**CHARTER TOWNSHIP OF GARFIELD
PLANNING COMMISSION MEETING**

Wednesday, March 12, 2025 – 7:00 pm
Garfield Township Hall
3848 Veterans Drive
Traverse City, MI 49684
Ph: (231) 941-1620

Charter Township of Garfield Planning Department Report No. 2025-20			
Prepared:	March 5, 2025	Pages:	13
Meeting:	March 12, 2025 – Planning Commission	Attachments:	<input checked="" type="checkbox"/>
Subject:	TowerNorth Wireless Communication Facility Special Use Permit – Findings of Fact		
File No.	SUP-2024-02	Parcel No.	05-019-001-00 (part)
Applicant:	TowerNorth Development, LLC		
Agent:	Jaime Mathew w/Kimley-Horn and Associates, Inc.		
Owner:	Frank A Bare

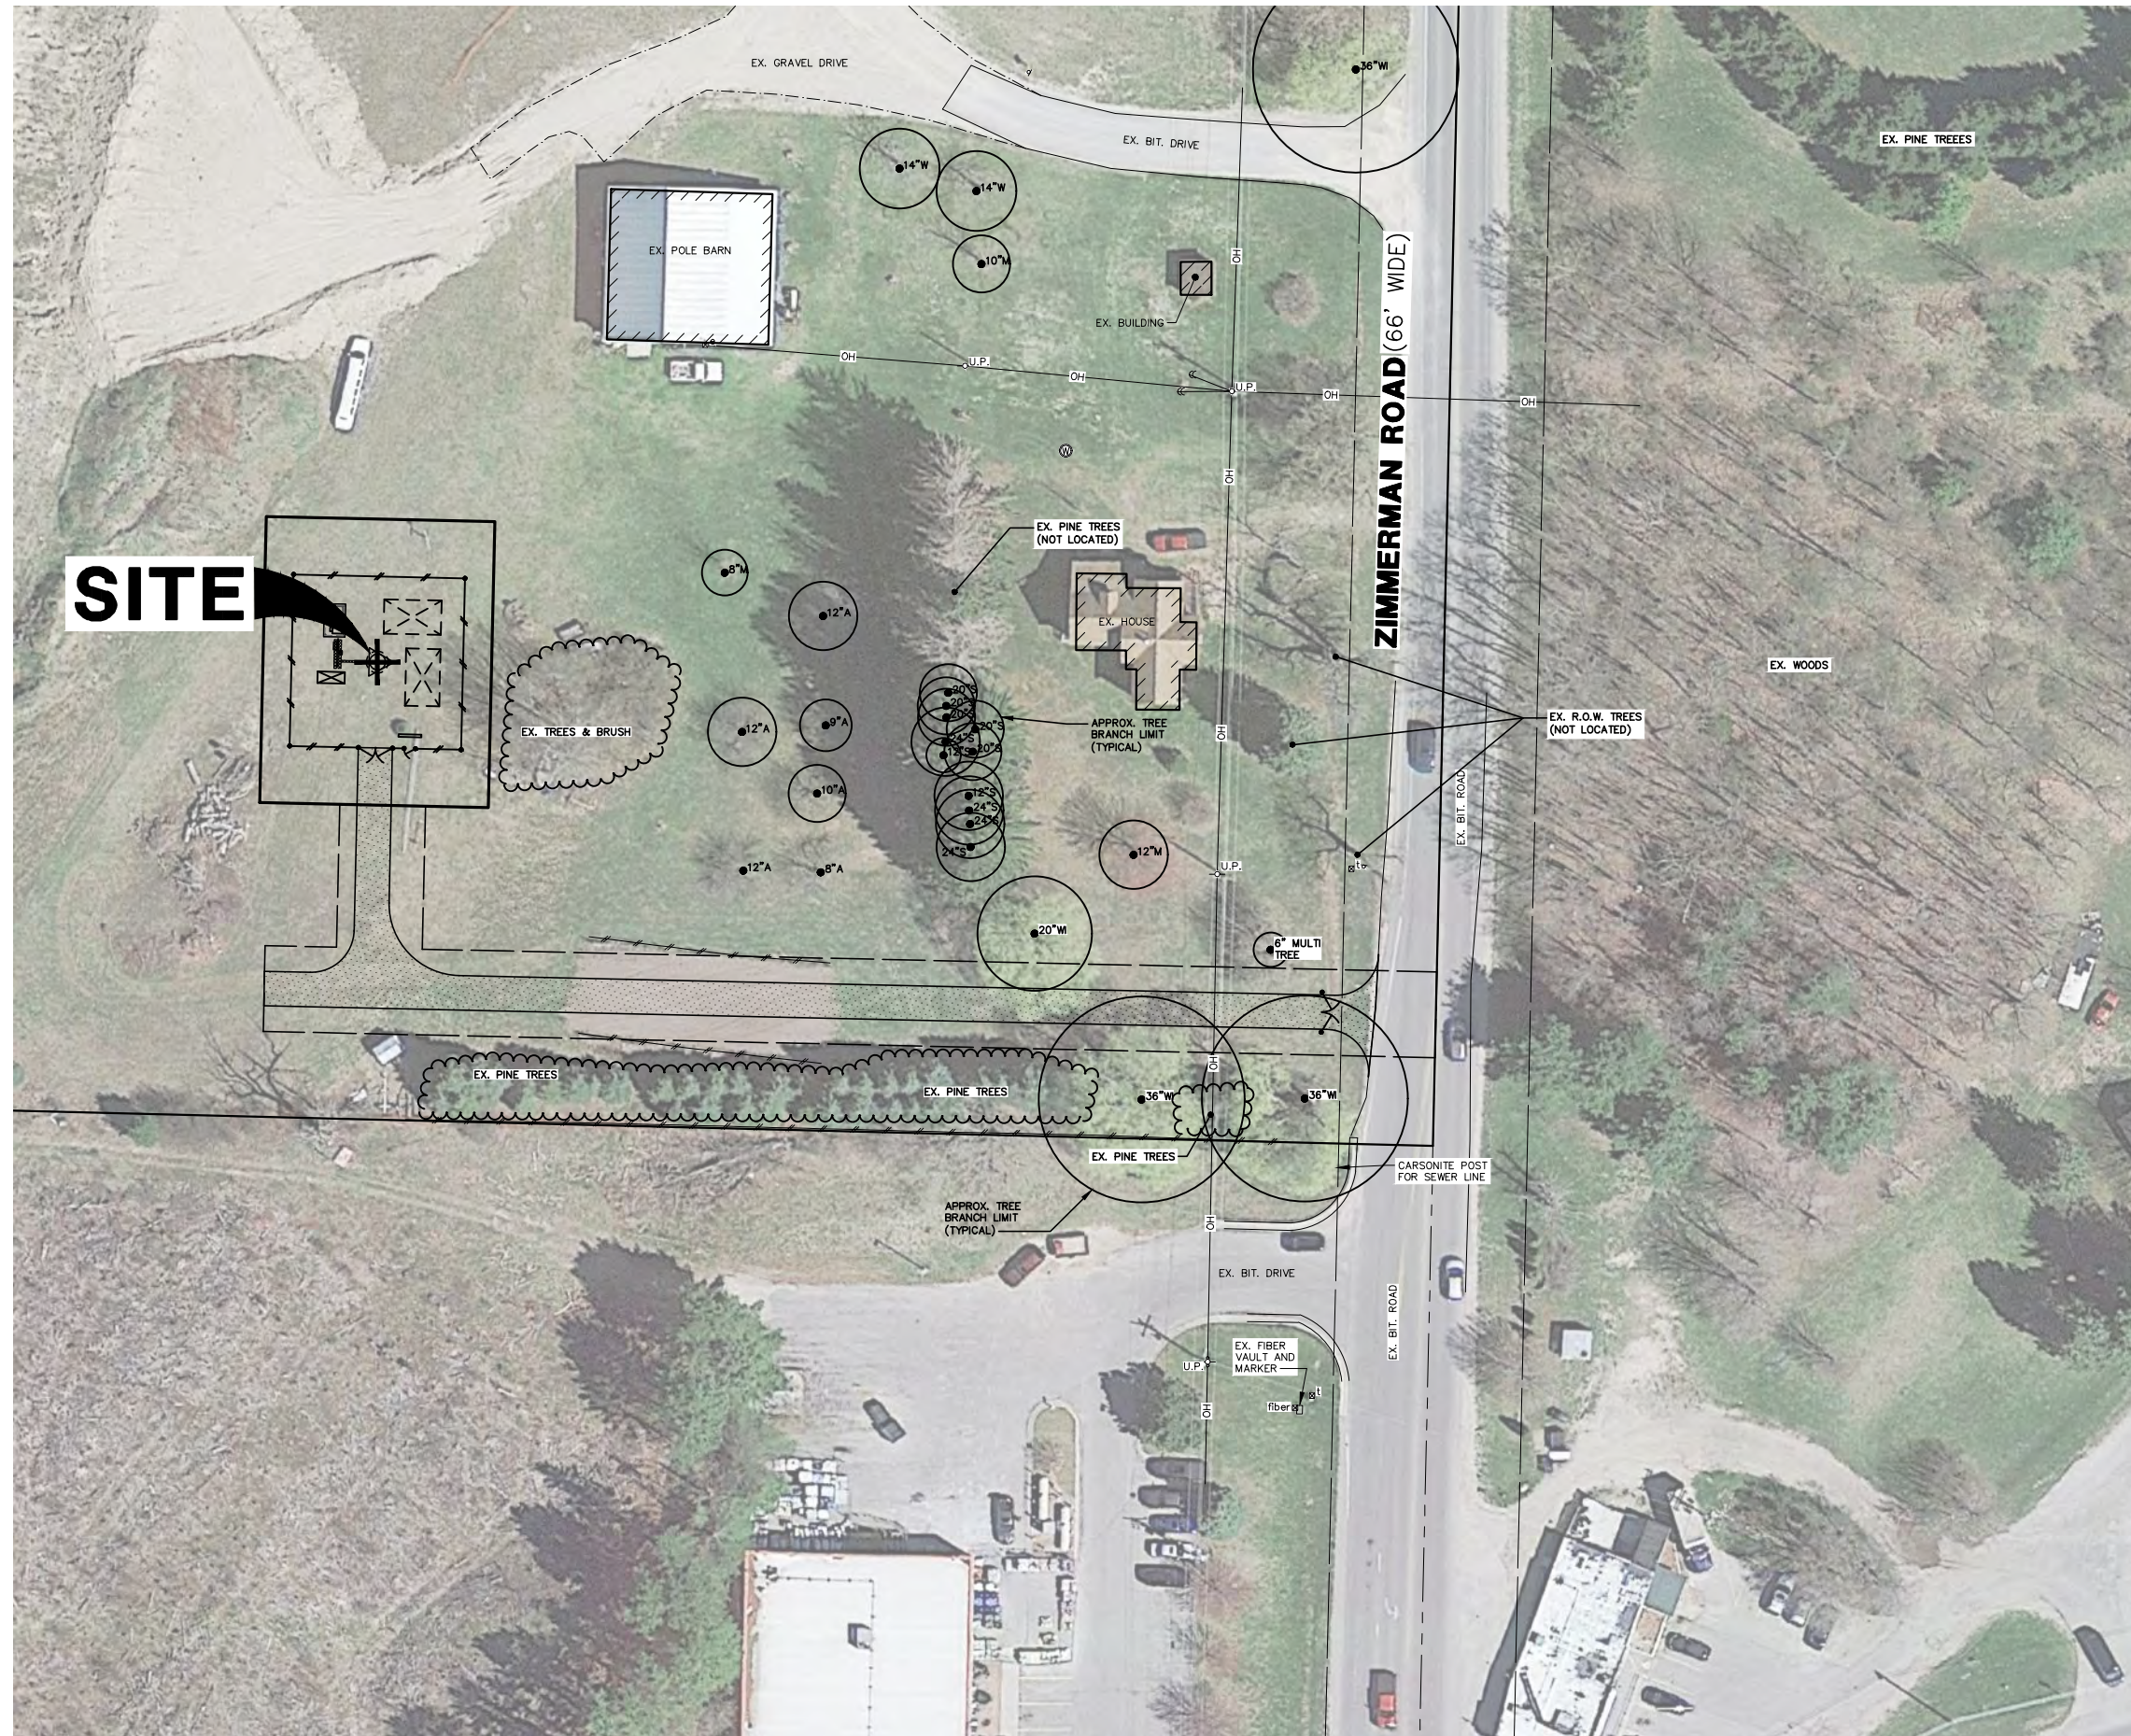
- The updated site plan shows a 60' x 60' fenced-in area with a 6'-high chain link fence and indicates that there will be a 12-foot-wide double leaf gate and a 4-foot-wide swing gate for the fenced area.
- There is also a proposed entrance gate for the drive leading up to the leased area, details of which are shown on the site plan.

- The cover letter indicates that the existing parcel has pine trees and landscaping along the property lines which provide natural screening.
- The updated proposed location is set further back from Zimmerman Road which helps to limit the visual impact of the tower on the road right-of-way and to the east.
- The site plan shows an extensive existing landscape buffer on the south lot line.
- Given that the updated proposed tower location is beyond the existing landscape buffer to the south, additional plantings are needed to screen the tower from the south. An updated site plan shall be submitted with additional landscaping to provide screening along the south lot line, in accordance with the landscaping requirements of the Zoning Ordinance.

- Given that the updated proposed tower location is beyond the existing landscape buffer to the south, additional plantings are needed to screen the tower from the south. An updated site plan shall be submitted with additional landscaping to provide screening along the south lot line, in accordance with the landscaping requirements of the Zoning Ordinance.

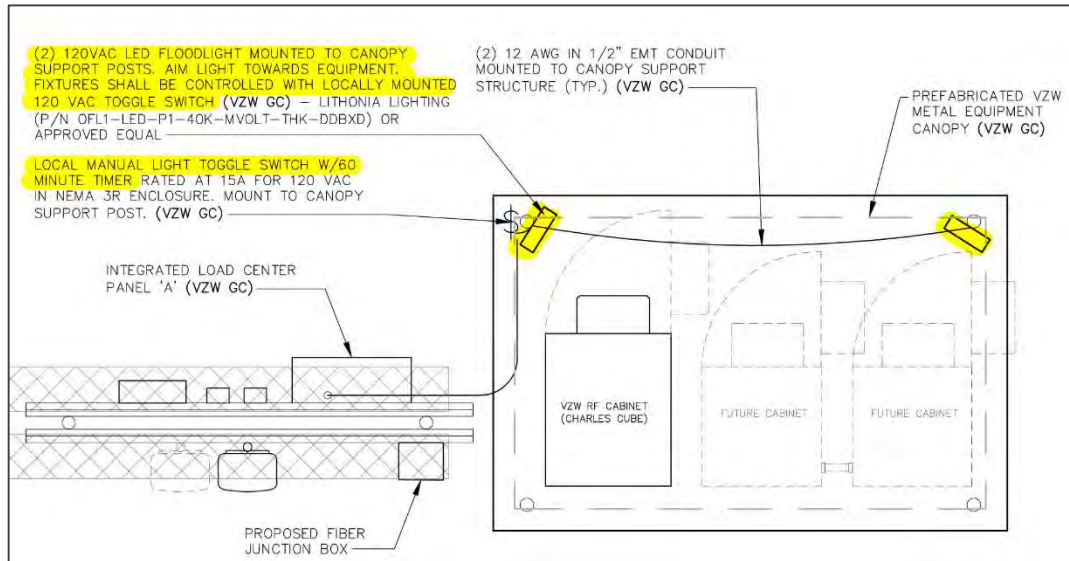
5. Zoning Ordinance Standards – The purpose statement for Section 423 Special Use Permits indicates that every “special use permit application or amendment shall, at a minimum, be required to comply with every requirement contained in each article of this ordinance.” Staff offers comments on the following sections of the Zoning Ordinance:

a. Lighting – The site plan notes there “are two, low wattage (21W), LED lights proposed as part of this project.” Please provide details on the proposed lighting including cut sheets for the proposed fixtures and a photometric plan to determine if the lighting standards of Section 517 are met.

07/02/2024 Response: Please see the attached cut sheet for the light fixture. The proposed lights provide 0.5-foot candles at approximately 30ft from the light location based on the mounting height of 8ft above grade with shielding provided by the proposed canopy.

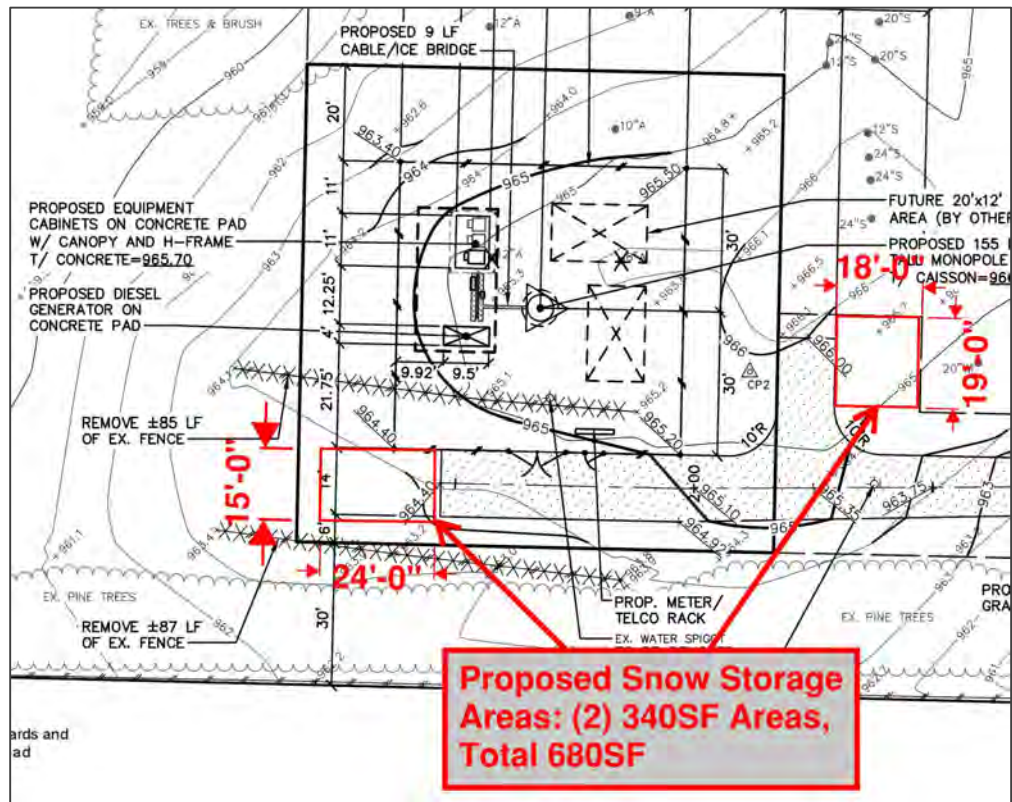
- b. Stormwater Management – Stormwater shall be detained on site and the stormwater system is subject to review by the Township Engineer. Please provide an escrow application for stormwater review.

Response: We are reviewing the submittal requirements for the stormwater review and escrow application (stormwater calculations, drainage arrows, and soil information) for our proposed site and we will work directly with the Township Engineer to submit a formal application and/or determine if any additional stormwater management is required.

07/02/2024 Response: We have reached out to the Drain Commissioner on the Stormwater review and permit to ensure that we are meeting the township’s requirement in our stormwater management plans. We will provide the final permit approval prior to submitting any building permit applications.

Commission's Proposed
Ollie's Entrance

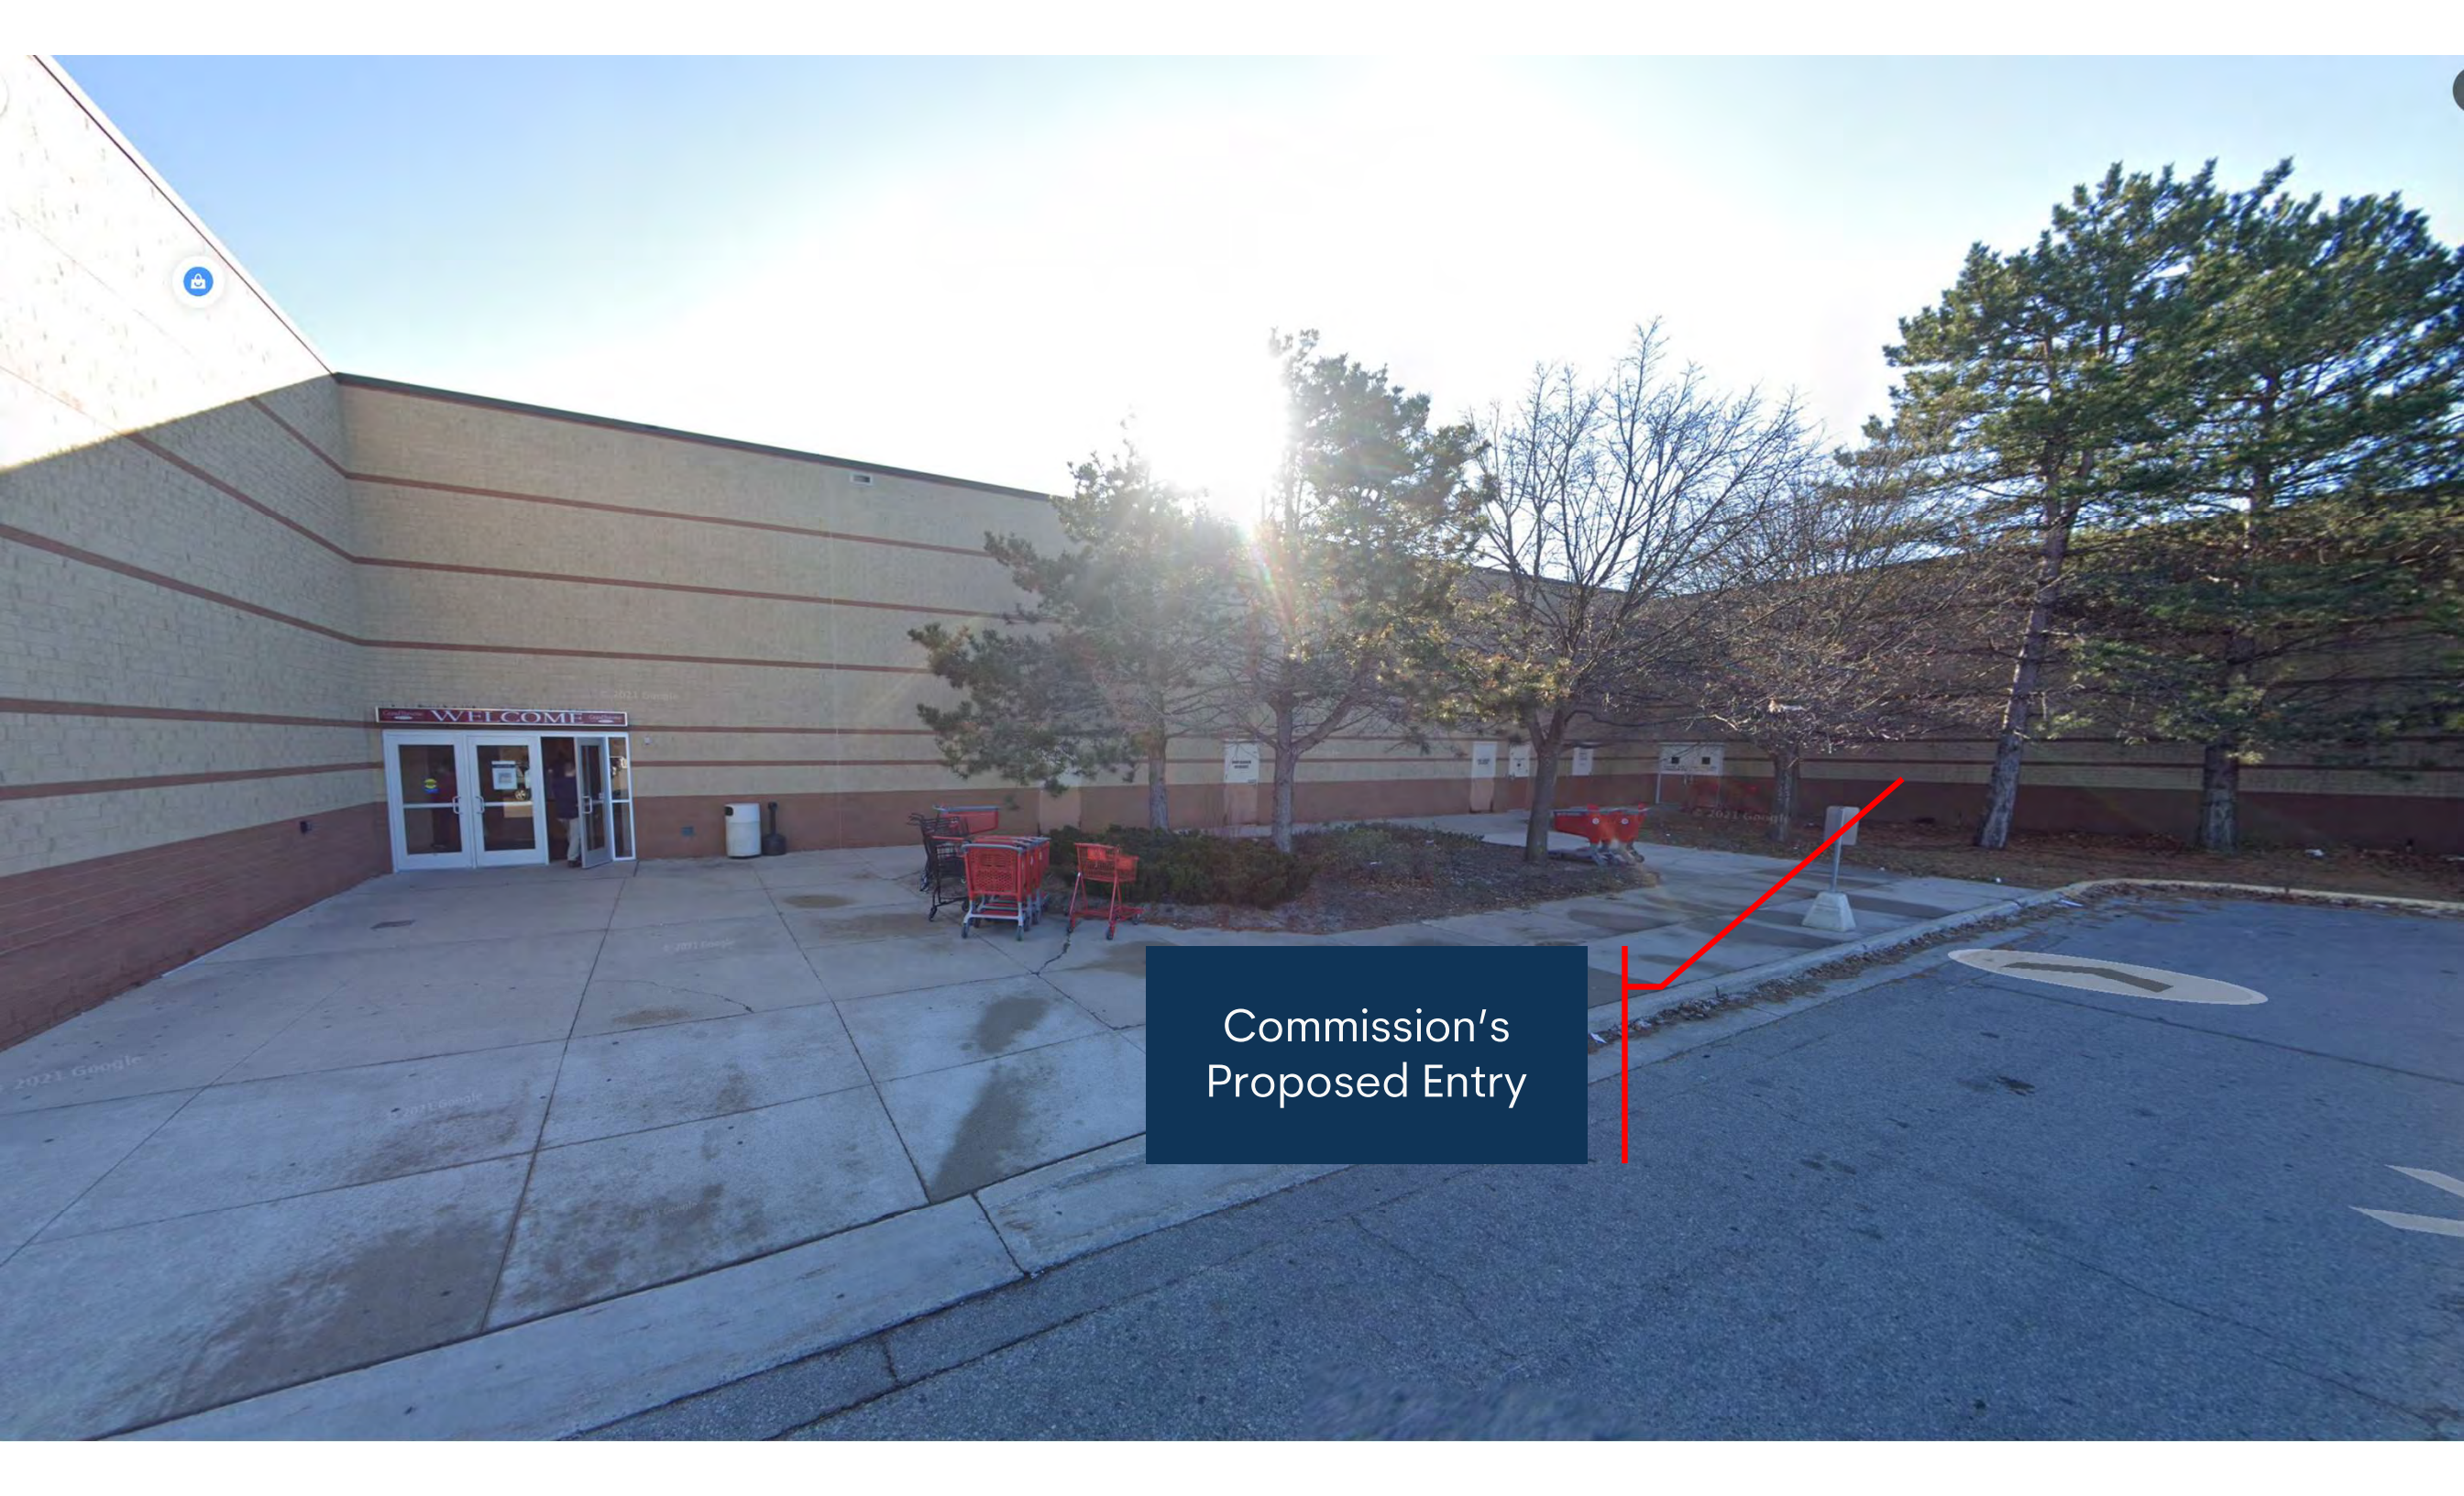
- *Location:* 3350 W South Airport Road, part of Grand Traverse Mall, northeast of South Airport and US 31
- *Development Description:* Proposed retailer in former TJ Maxx; proposed outdoor entrance/exit only
- *Status:* The Planning Commission reviewed the application at their 2/12/2025 meeting. Commissioners had some concerns and tabled the application to allow the applicants to respond to their comments.
